TITLE: **PRELIMINARY PLAT NO. 00029, PINE LAKE HEIGHTS SOUTH 4TH ADDITION**, requested by Ridge Development Company, for 204 lots and 12 outlots, with associated waiver requests, on property generally located between South 27th Street and South 40th Street, north of Yankee Hill Road.

Re: Preliminary Plat No. 00029
PINE LAKE HEIGHTS SOUTH 4TH ADDITION

LINCOLN CITY/LANCASTER COUNTY PLANNING STAFF REPORT

P.A.S.: Change of Zone #3297 (R-4, B-2, and O-3 to R-3)
Change of Zone #3298 (R-3 to R-4, B-2 and O-3)
Preliminary Plat # 00029 Pine Lake Heights South 4th Addition
Use Permit #134

SHEET 3 OF 14

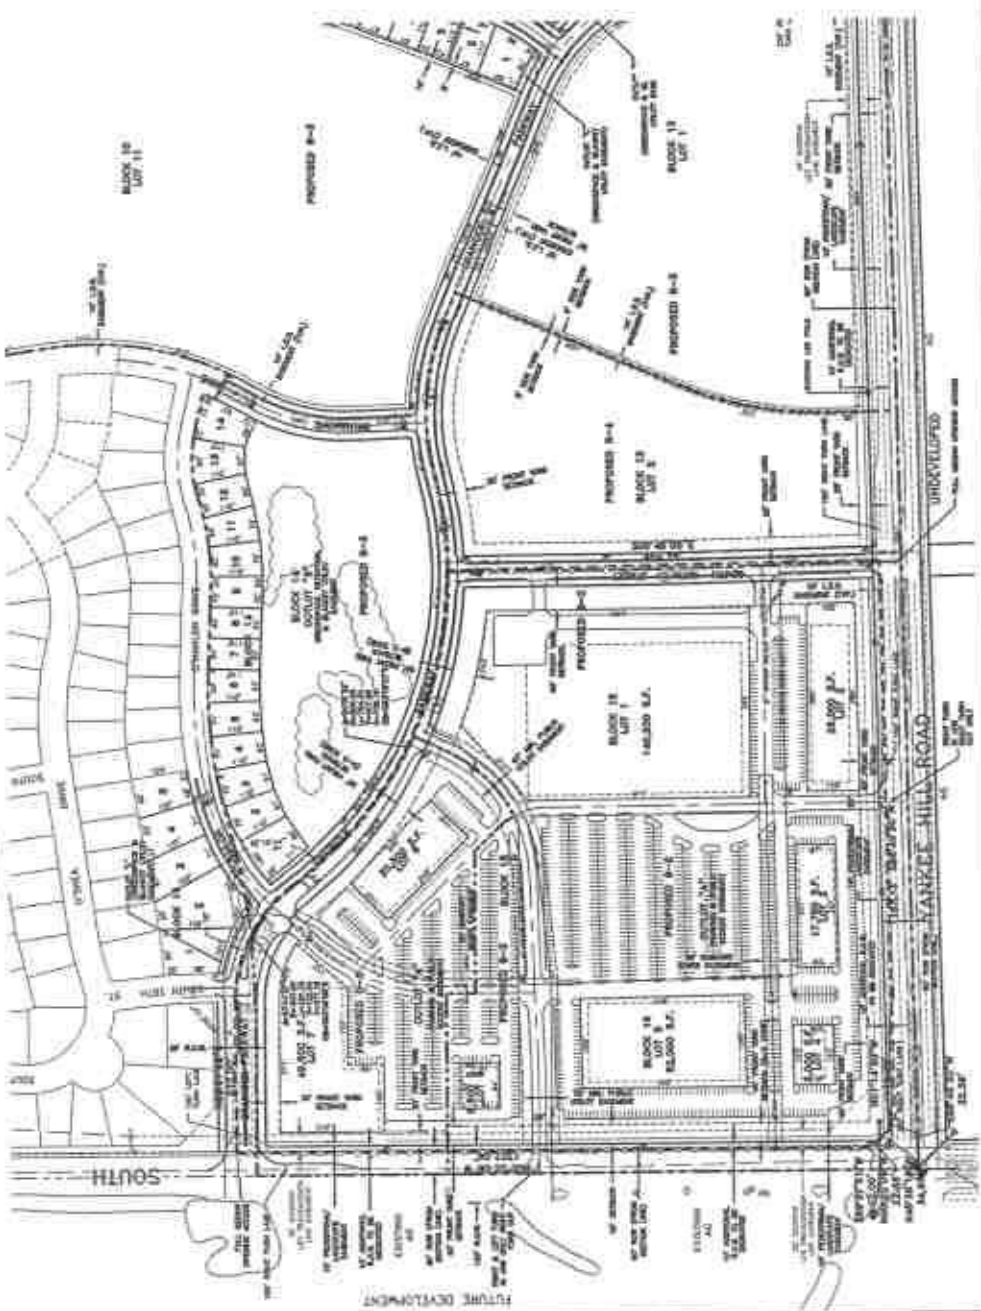
1.1.16 Revise notes on Sheets 2 and 3 from "10' Pedestrian/Landscape Easement" to "10' Pedestrian/Bike Trail/Landscape Easement" for that easement along Yankee Hill Road. **(**As requested by staff and approved by Planning Commission on 01/09/02**)**

1.1.16 Revise notes on Sheets 2 and 3 from “10' Pedestrian/Landscape Easement” to “10' Pedestrian/Bike Trail/Landscape Easement” for that easement along Yankee Hill Road. (****As requested by staff and approved by Planning Commission on 01/09/02****)

- 1.1.16 Revise notes on Sheets 2 and 3 from "10' Pedestrian/Landscape Easement" to 10' Pedestrian/Bike Trail/Landscape Easement" for that easement along Yankee Hill Road.
